From: Max Weidman (adpce.ad) <Max.Weidman@arkansas.gov>
Sent: Wednesday, June 24, 2026 1:23 PM
To: Andrew Miller, PG <amiller@mce.us.com>
Cc: Greg Banic (adpce.ad) <Greg.Banic@arkansas.gov>; Kimberly Davenport (adpce.ad) <Kimberly.Davenport@arkansas.gov>
Subject: City of Camden Class 4 AEIR

CITY OF CAMDEN CLASS IV LANDFILL
2023 AEIR

SURFACE COMPARISON 2024/ULTIMATE

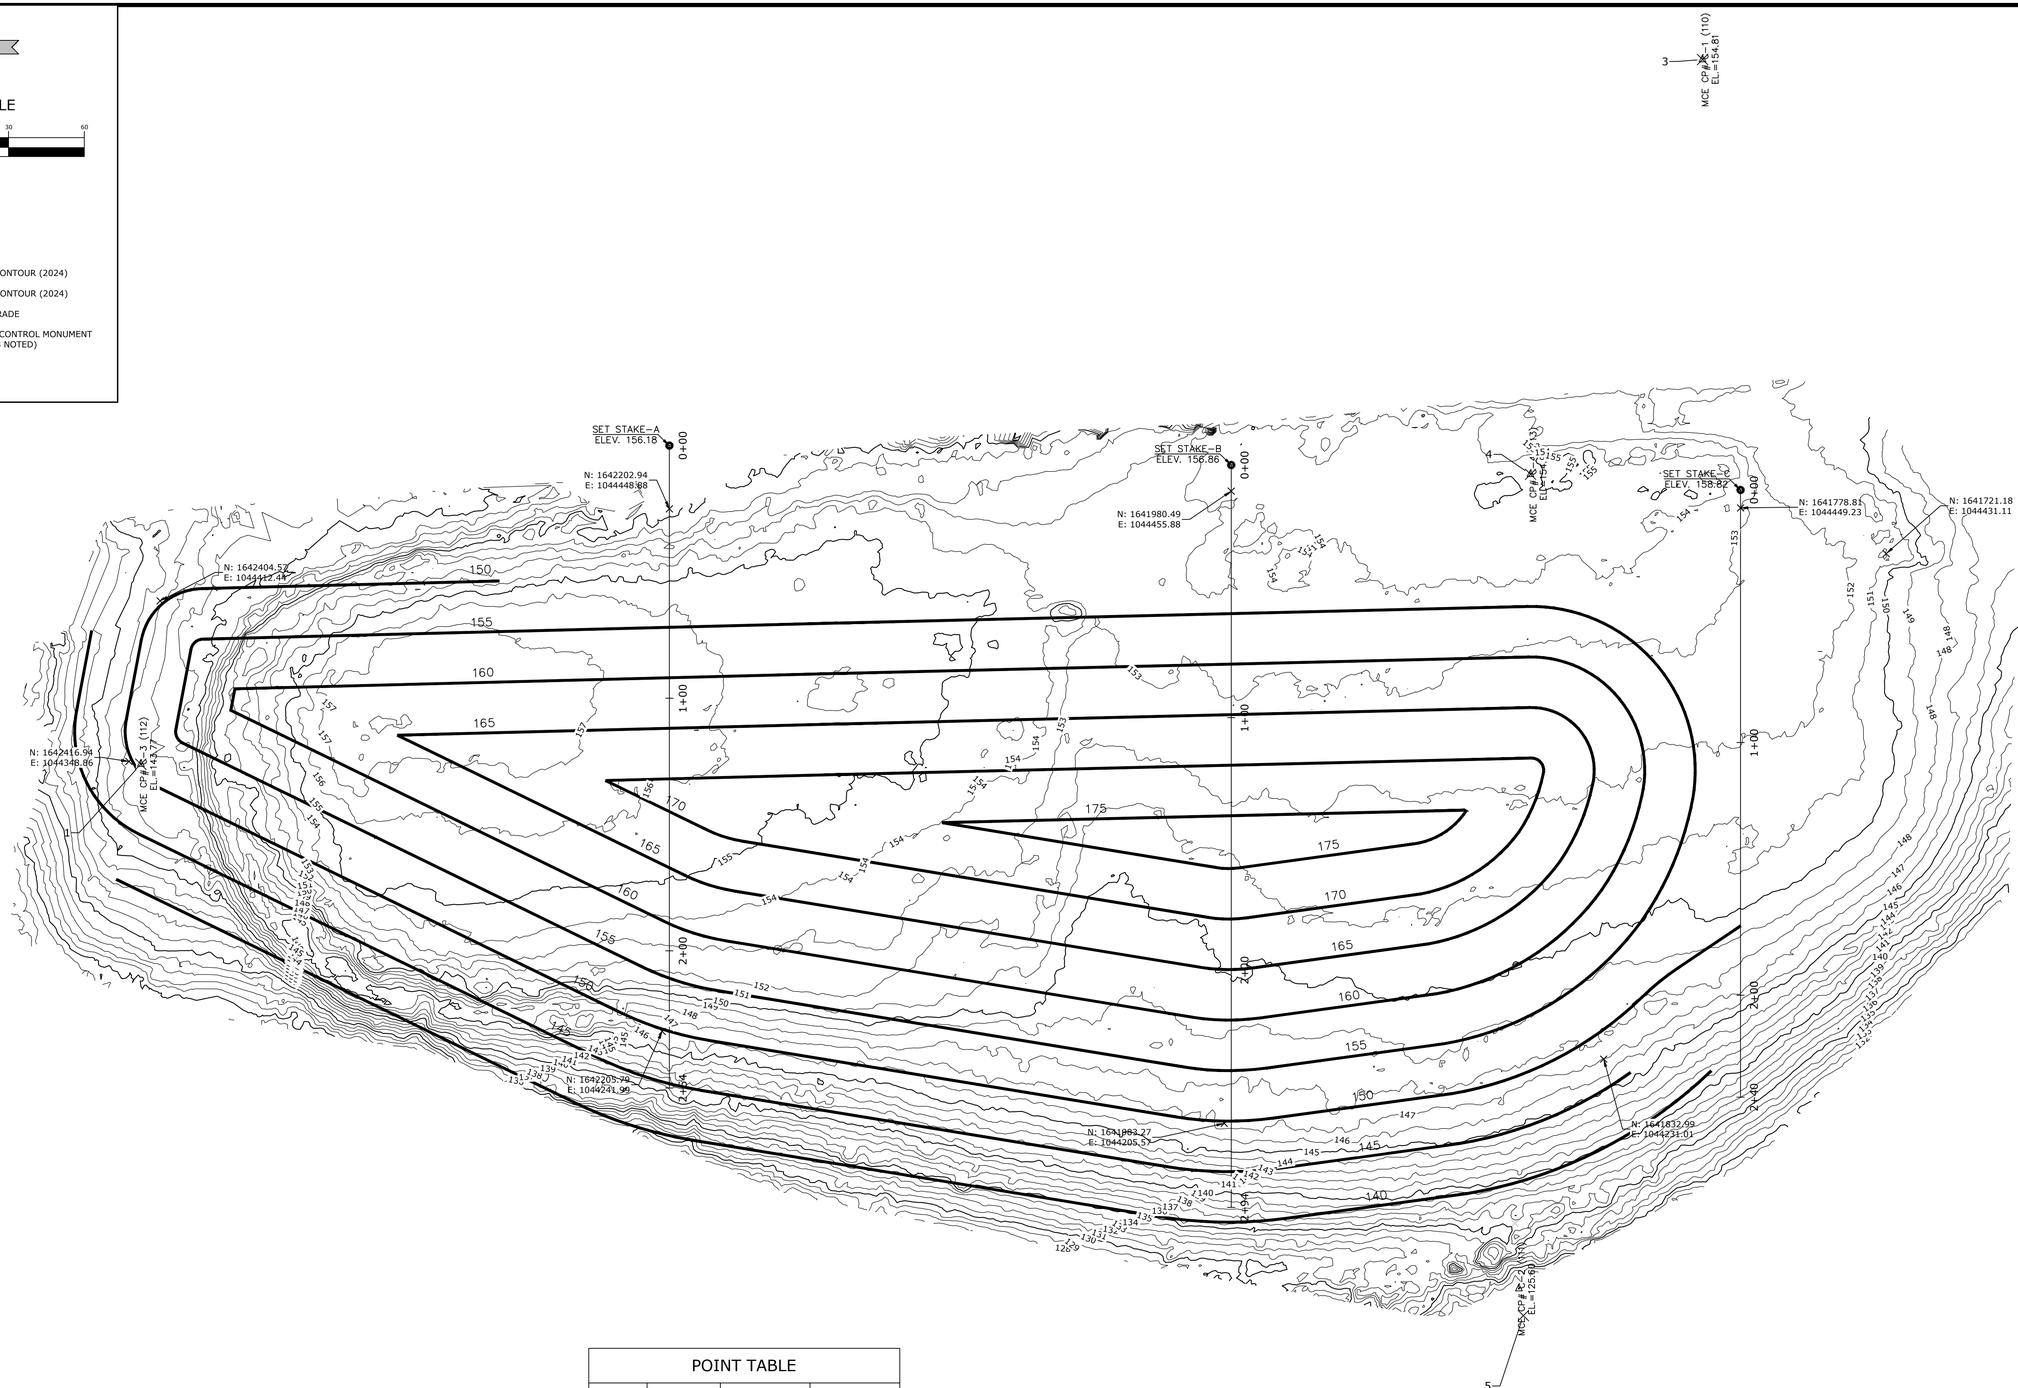
While I was reviewing the recently submitted AEIR for the Camden Class 4 landfill I noticed that for 2023 and 2024, the amount of airspace remaining in the current cell stayed the same in 2023 and 2024, and expanded by approximately 20,000 cubic yards in the 2025 AEIR. Both the 2024 and 2025 AEIRs show that waste was received at the landfill, but state that 0 airspace has been used in those two calendar years. Can you provide some clarification on how this is possible? No modification applications have been received by DEQ to my knowledge. If you believe this is in error, please

submit revisions for the available airspace as of the end of 2025 and the remaining site life of the facility by July 8th, 2026. Please let me know if you have any questions.

Max.
In 2025, we did a new Air Space calculation based on the existing ground compared to a completed final surface. See attached file. Remaining Air Space is 36,385 cu.yds.

There was an error in the 2025 AEIR, which we will correct and resubmit. The landfill surface did see some air space fill of approximately 7304 cu.yd from 2024 to 2025.
